Automatic Emergency Braking and Lane

Departure Warning Systems (AEBS/LDWS)

Proposal for a Draft 01 Series of Amendments to the Regulation on advanced emergency braking system

Submitted by the Informal group on Automatic Emergency Braking and Lane Departure Warning Systems (AEBS/LDWS) *

Annex 2, amend to read:

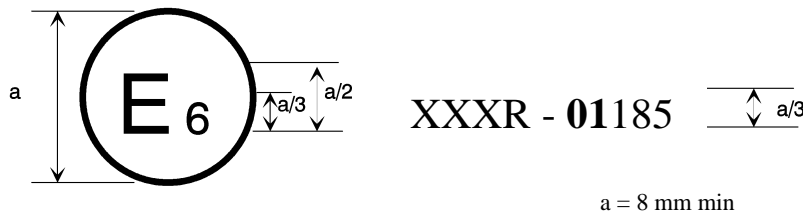
The above approval mark affixed to a vehicle shows that the vehicle type concerned has been approved in Belgium (E6) with regard to the AEBS pursuant to Regulation No. XXX. The first two digits of the approval number indicate that the approval was granted in accordance with the requirements of **the 01 Series of Amendments to the Regulation No. XXX in its original form.**
